800 East Main Street

preliminary Final Environmental Impact Statement (pFEIS)

Town of Yorktown

AKRF, Inc.
34 South Broadway
White Plains, New York 10601

- 36,000 cars per day = two lanes required
- Minimum 180'-230' roundabout – extends beyond existing right-of-way
- Land takings required
- Realignment of US Route 6 and East Main Street

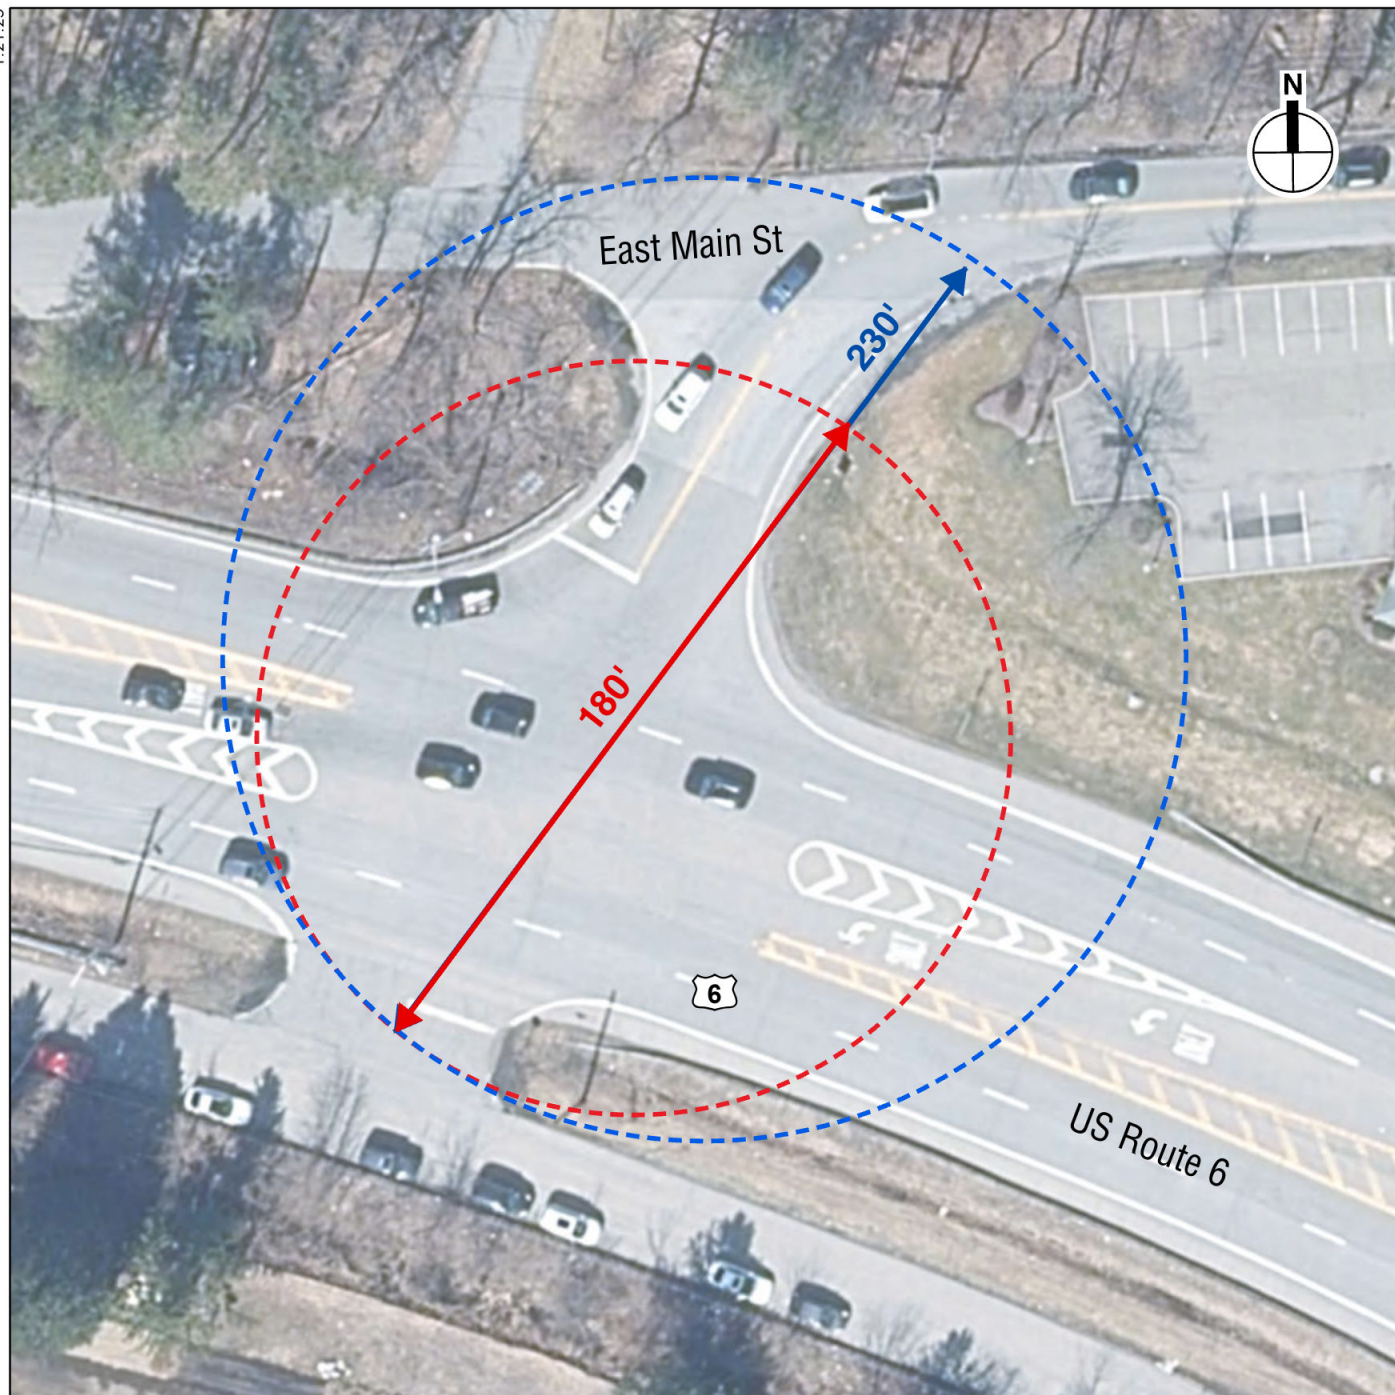
And to add another, let's just figure 200 homes, 400 cars, on that end, forget about the 100 garbage trucks that are going to be coming in and out of the other plan, and then the other 200 homes that might happen at the other end, and then 150 homes down the street. You're adding like 1,000 cars to a little tiny section of road that can't handle what's there now. He told you it's an F for the intersection, it's a total failure. So, if it's totally failing now, how do you think two traffic lights are going to fix it. It's just not going to work. (017_Deer_PH_09-03-2024)

Response 64: A traffic circle, or roundabout, would be infeasible at the US Route 6 and East Main Street intersection due to the amount of space and corresponding land takings that would be required to build a roundabout to handle the traffic volume and speeds at this location (see **Figure 2-1**, which was presented at the October 8, 2024 public hearing). As shown at the October 8, 2024 public hearing, the proposed traffic signals at US Route 6 and East Main Street would be synced to the adjacent traffic signals to prevent additional delay and stops at the intersection. The traffic signals would provide a protected left turn phase to reduce vehicle conflicts between westbound vehicles, eastbound left turning vehicles, and southbound right turning vehicles. Adding stop signs at the intersections of Hill Boulevard and E Main Street and Lee Boulevard and E Main Street may some deter vehicles from utilizing the US Route 6 and E Main Street cut-through, but would not reduce the existing vehicle conflicts. Additionally, an analysis of alternative site access, including a potential connection from the Project Site to US Route 6, which was deemed to be infeasible, is described in Chapter 12 Section F.9 of the DEIS and in Response to Comment 82.
